RE: Required Counter Die Fin Section Project: Lodha Bradbury Mumbai.

Q02050

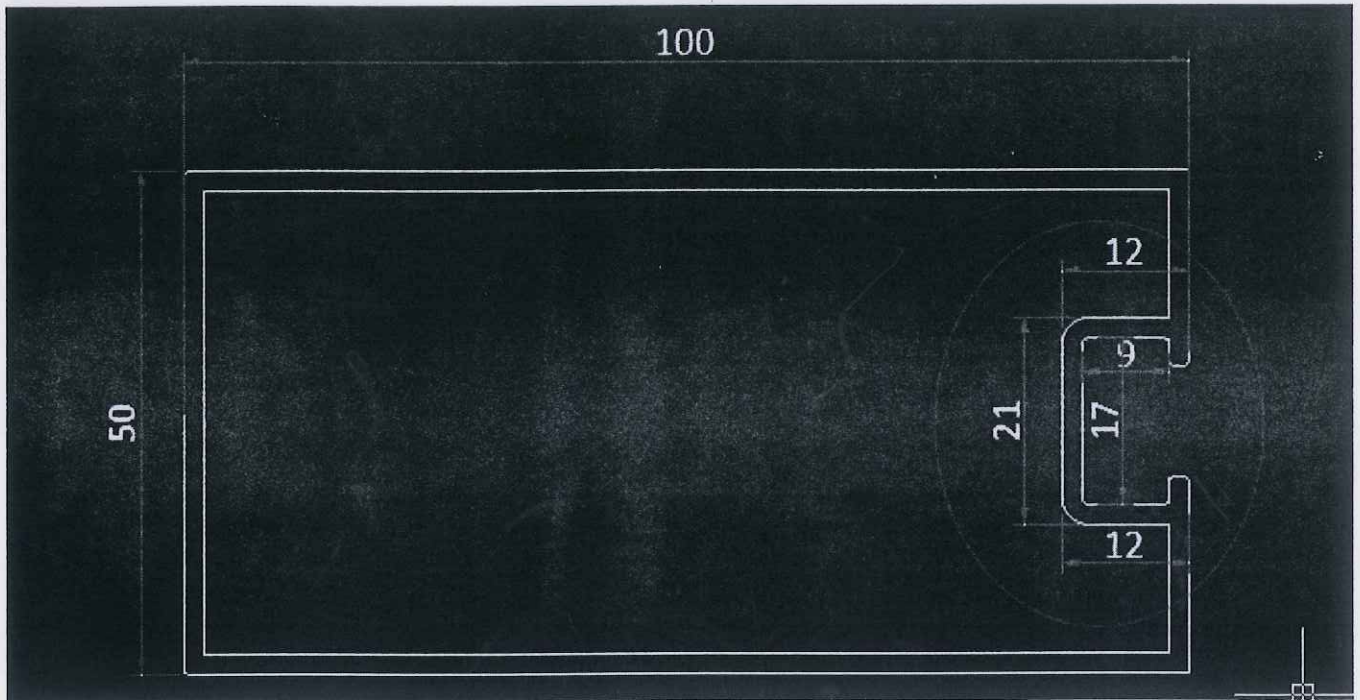
Fin details are completely different so please procss for new die

Similar to E0595

Required profile is similar with E0595
